Freedom of Information Document Schedule for FOI: File: 701-022-0015

Establishment and operations of Energy Services Environmental (ES), a Re: company which provided dechlorination and recycling services from a site on Dacre Street in Mitchell.

To			
From	Job no	CA090050	Revision no 1.0
Date	1 February 2010	Pages	3
Subject	Block 15, Section 22, Mitchell, ACT

ACT FIRE BRIGADE FIRE SAFETY SECTION PLAN REPORT

Figure 1 Fire hose reels on the mezzanine level

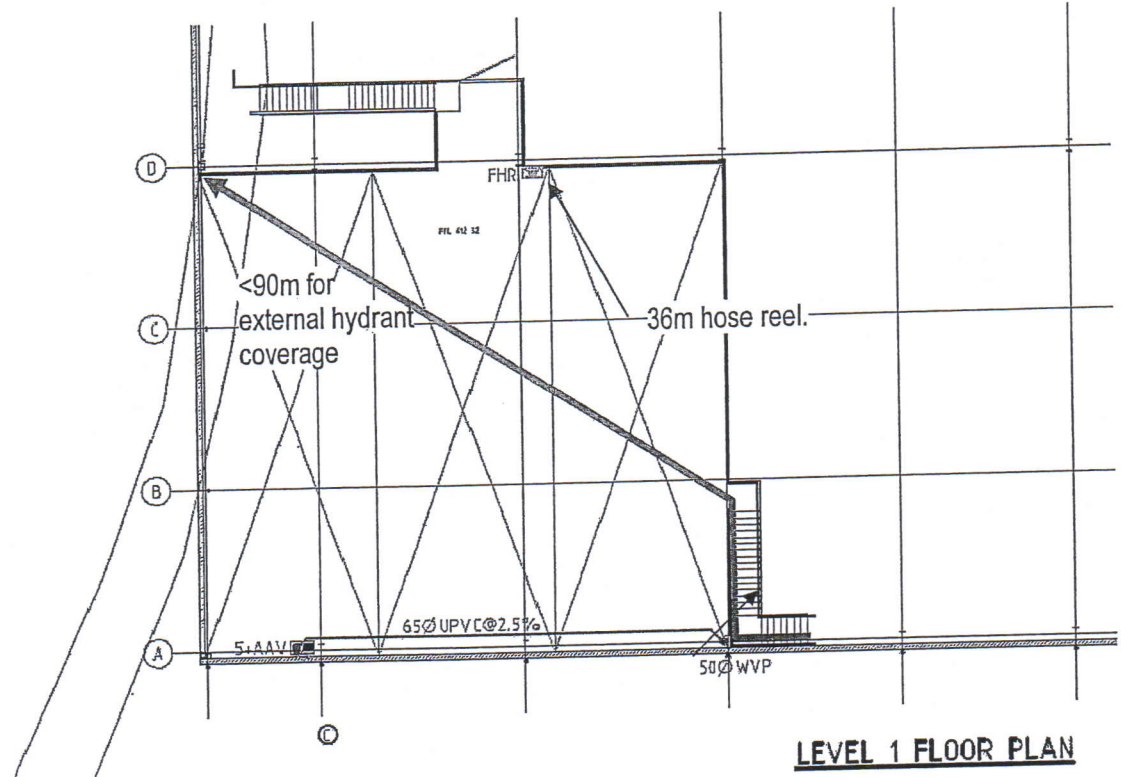
- 5. A fire hose reel system must be installed throughout the building in accordance with the requirements of clause E1.4 of the BCA and AS 2441-2005. In particular, a 36m fire hose reel will be needed within 4m from the northern stairway on the mezzanine level – refer to Figure 1.

5.	<p>A fire hose reel system must be installed throughout the building in accordance with the requirements of clause E1.4 of the BCA and AS 2441-2005. In particular, a 30m fire hose reel will be needed within 4m from the northern stairway on the mezzanine level – refer to Figure 1.</p>	<p>Yes</p>	<p>Compliance certificate for the installation of the fire hose reel system has been received from i M Leemhuis Plumbing and Gas dated 20/01/2010. Defire has inspected the fire hose reel.</p>

Figure 2 Hardstand location and signage requirements on the ground floor

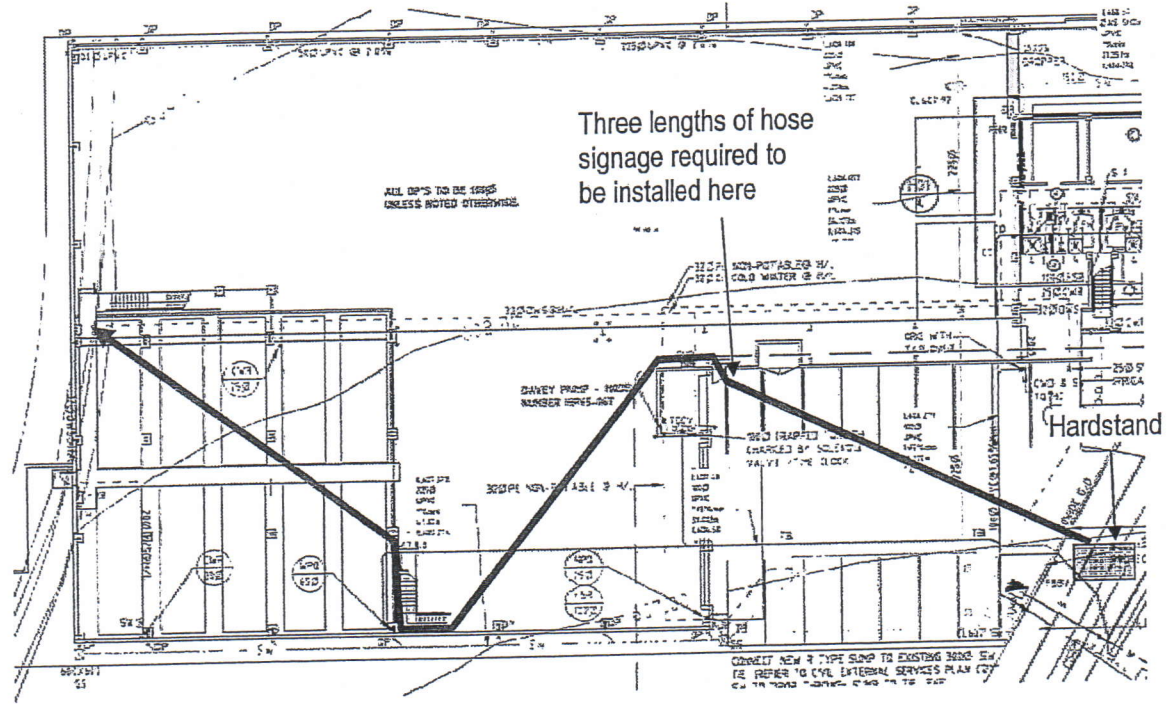
- a. Signage must be provided at the entrance to the building to clearly identify that the use of three hoses is required to achieve full coverage – refer to Figure 2. The signage is to be in 20mm high capital letters in a colour contrasting to the background and say "COVERAGE FROM THE EXTERNAL FIRE HYDRANTS IS ACHIEVED WITH THE USE OF THREE HOSE LENGTHS".

- b. A hydrant location plan showing the location of the external street hydrants is to be provided as part of or adjacent to the signage referred to in item 4a above. The minimum size of the hydrant location plan is to be A4.

a.	Signage must be provided at the entrance to the building to clearly identify that the use of three hoses is required to achieve full coverage – refer to Figure 2. The signage is to be in 20mm high capital letters in a colour contrasting to the background and say "COVERAGE FROM THE EXTERNAL FIRE HYDRANTS IS ACHIEVED WITH THE USE OF THREE HOSE LENGTHS".	Yes	Defire has inspected the signage.

b.	A hydrant location plan showing the location of the external street hydrants is to be provided as part of or adjacent to the signage referred to in item 4a above. The minimum size of the hydrant location plan is to be A4.	Yes	Defire has inspected the hydrant location plan.
